MEMORANDUM

TO: Parks and Recreation Board Members

SUBJECT: Town Lake Park Gazebos

SUBJECT: Walnut Creek / Colorado River Greenbelt.
Walnut Creek low-flow Diversion Project.

EXHIBIT 'B'
PERMANENT
EASEMENT
0.318 AC.

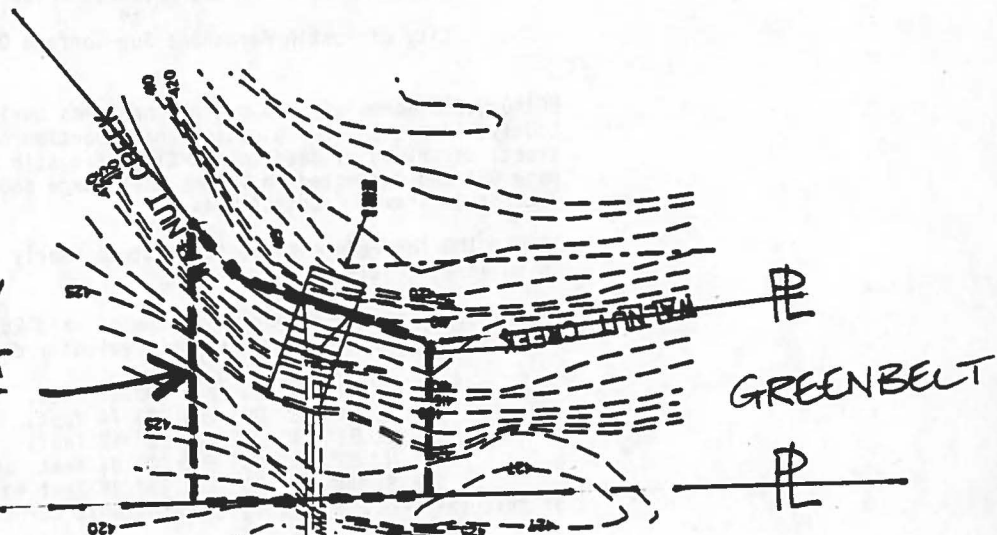
Some comments related to the metes and bounds field notes were not addressed in the revised documents. Parks and Recreation staff comments proposed that references to a "Public Utility Easement" be deleted and that easement description be "Permanent Subsurface Drainage Easement".

Also proposed was that references to "City of Austin Inc." be deleted and replaced with "City of Austin".

To address the concerns of the PARD staff regarding the easements, reference to the easement as "Public Utility Easement" has been deleted and the description has been revised to read as "Permanent Subsurface Drainage Easement". Copies of revised field notes are attached.

TOP VIEW

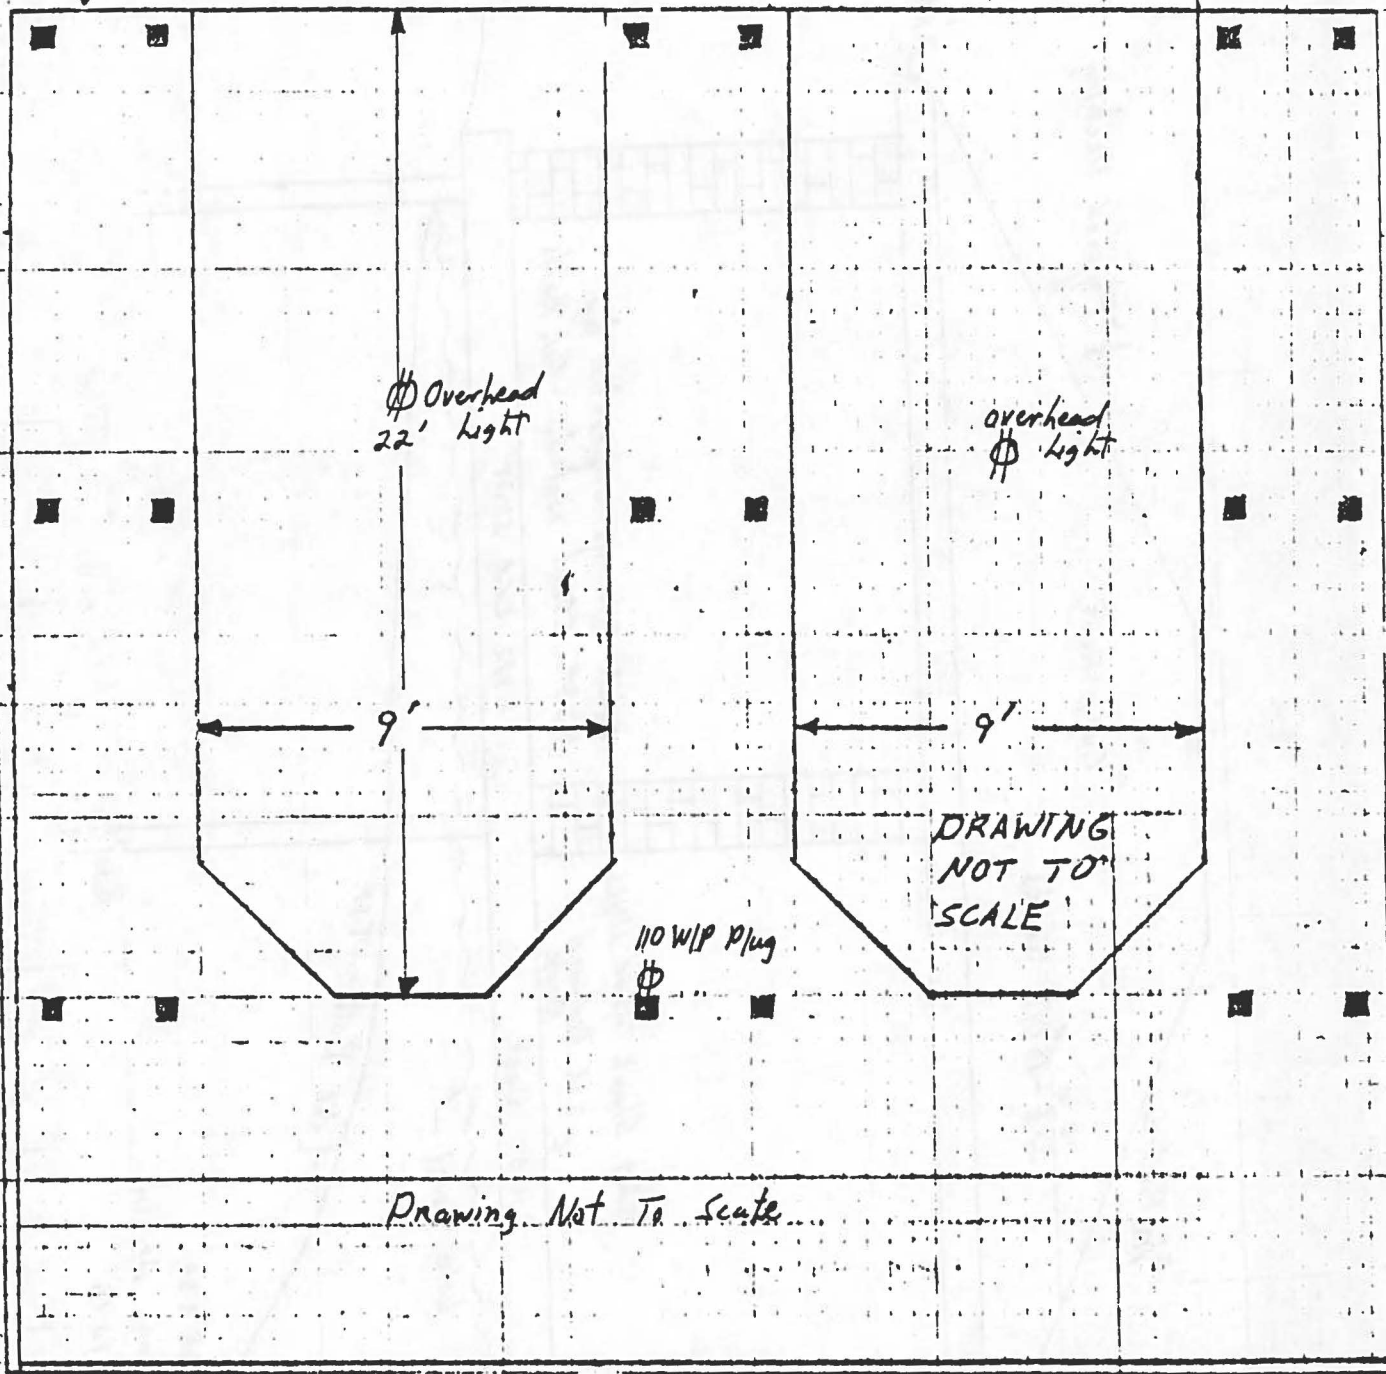
The request is to increase the width of the dock from 20' to 27', which is 20% of the total shoreline length of 136.3'. Attached are details of the project.

We would like to enlarge the boat dock request for 2201 Island Wood Road from 20 feet wide to 27 feet wide that is permit number 9008842.

I recommend approval of the request to amend the previous approval to construct a boatdock at 2201 Island Wood Road, in accordance with the revised drawings attached.
